**Joseph M. Farley Nuclear Plant Units 1 and 2**  
**10 CFR 71.95 Report on Potential Issues Involving Radwaste Cask 8-120B**

**Subject: 10 CFR 71.95 Report on the 8-120B Cask**

**Failure to Observe Certificate of Compliance Conditions  
for the 8-120B Vent Port Pre-Shipment Leak Test**

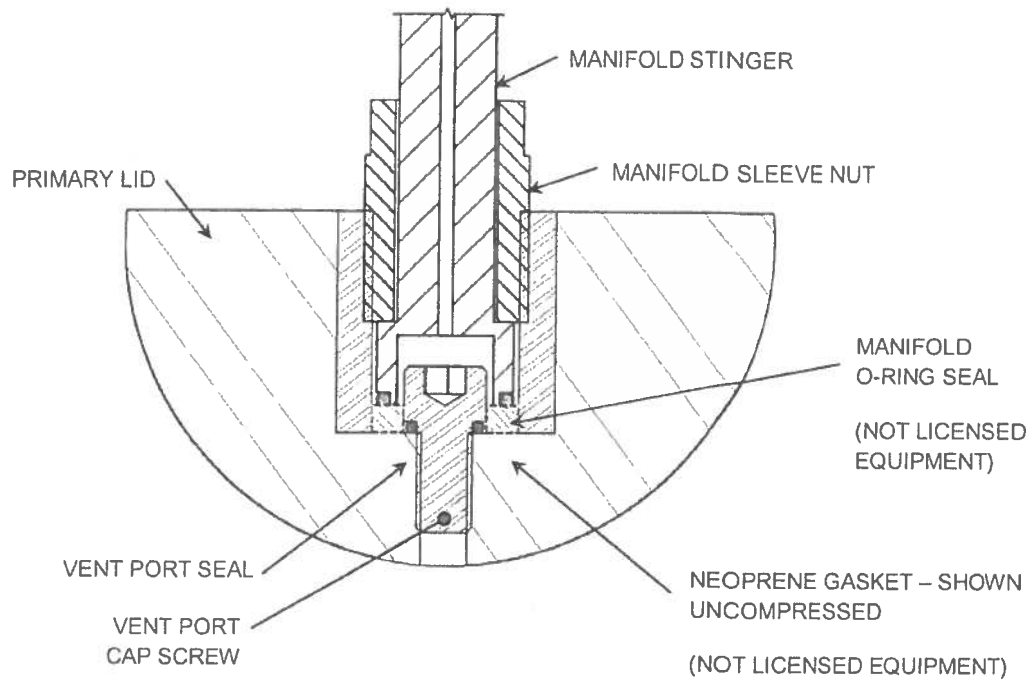
The neoprene gasket can constrict on the head of the vent port plug cap screw when it is compressed by the bottom end of the test manifold stinger, which could reduce the sensitivity of the pre-shipment leak test. Consequently, the vent port pre-shipment leak tests performed using the neoprene gasket may not have provided the required test sensitivity of  $1 \times 10^{-3}$  ref-cm<sup>3</sup>/sec.

The pre-shipment leak test of the vent port is a pressure drop test performed using a dedicated test manifold. The test manifold is not a part of the licensed package. It includes a stinger (shown below), an O-ring seal that contacts the stinger and the bottom of the vent port hole, and a sleeve nut to compress the O-ring seal. The test manifold was designed so that it surrounds the vent port cap screw, leaving a small gap between itself and the vent port cap screw. The 8-120B cask fleet began to ship with a new lid design in September 2013, and operations staff noted more frequent difficulty getting the manifold to seal. It became desirable to find a better way to seal the bottom of the manifold in order to minimize operator exposure. They found that adding a neoprene gasket (also not part of the licensed package) under the base of the stinger as shown below helped reduce testing time and exposure.

The new manifold gasket design, shown below, replaces the manifold O-ring seal and neoprene gasket previously used with a neoprene gasket that fits within the notch at the base of the manifold stinger.
